"RE-BUILDING THE CITY'S WATER SYSTEMS FOR THE 21ST CENTURY"

Addendum No. 5

Your reference is directed to **Contract 1415 – CARROLLTON WATER PURIFICATION PLANT WEST POWER COMPLEX FOUNDATIONS AND UNDERGROUND UTILITIES** for the Sewerage and Water Board of New Orleans which is scheduled to open at **11:30 a.m. Local time on February 8, 2023.**

Questions and Responses During Bidding

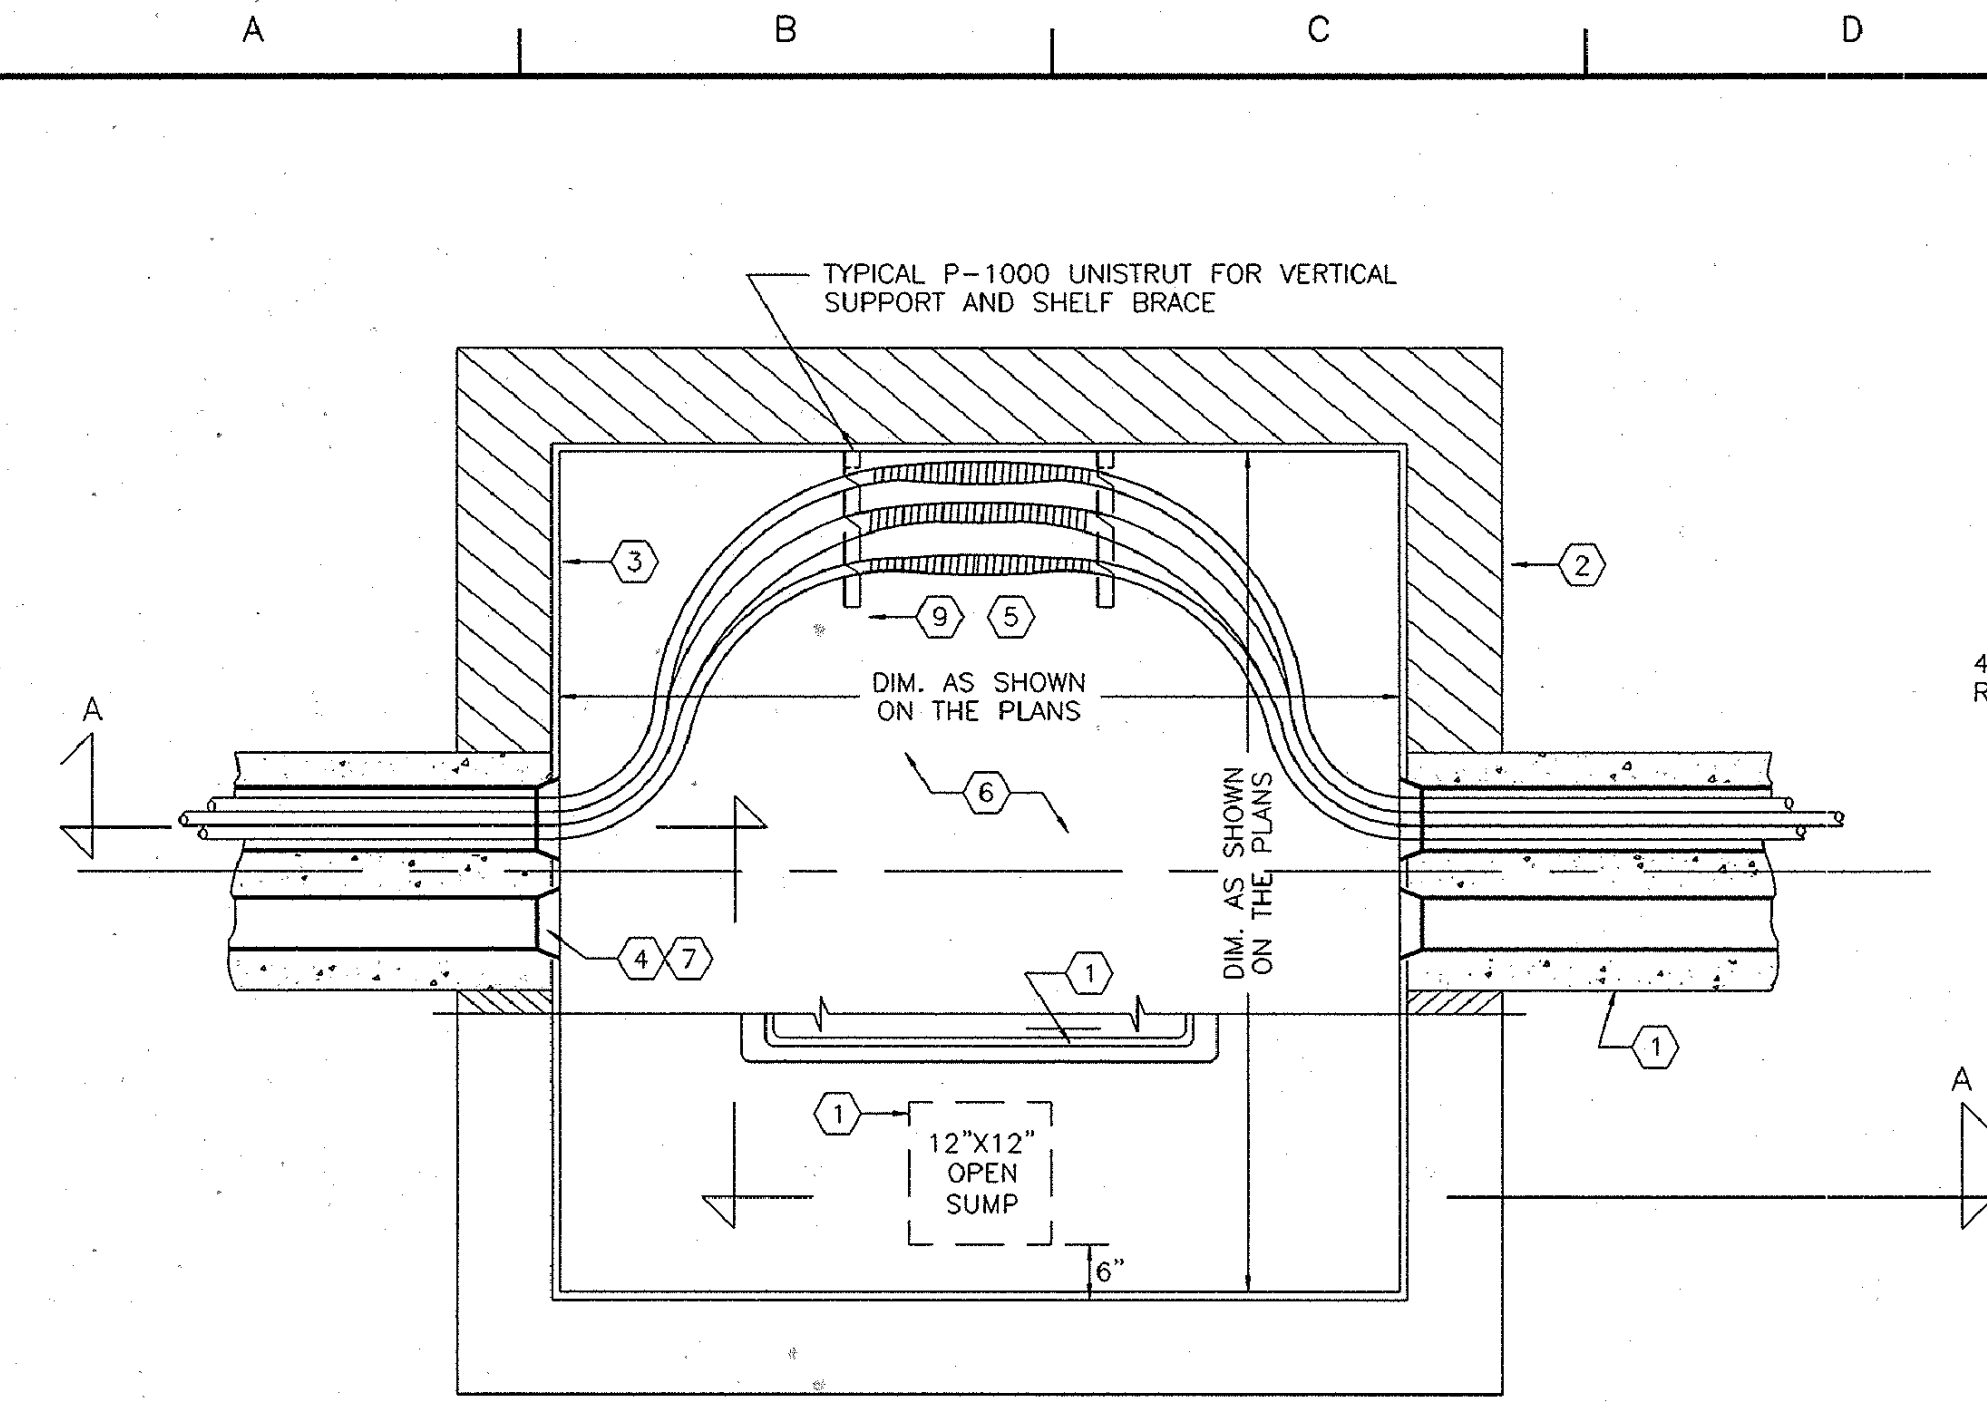
RESPONSE #72	For bidding purposes assume the subject ductbanks, per answer to BIDDER QUESTION 60 above, configure ductbank below the foundation with top-of-ductbank equal to bottom-of-foundation. The goal will be to embed the conduit in the foundation but do not have final OEM data to support specific conduit geometry(ies). Content shown is intended to characterize a bid-basis scope of work.
BIDDER QUESTION #73	Drawing 99.10 has a pile detail that differs from what is shown on S01-02-04. Please confirm which to use

RESPONSE #73	Please use the following revised detail for bidding purposes. The drawings will be revised in the conformed contract documents. Due to differences in pile caps and loads, dimensional details and rebar sizes may still vary.
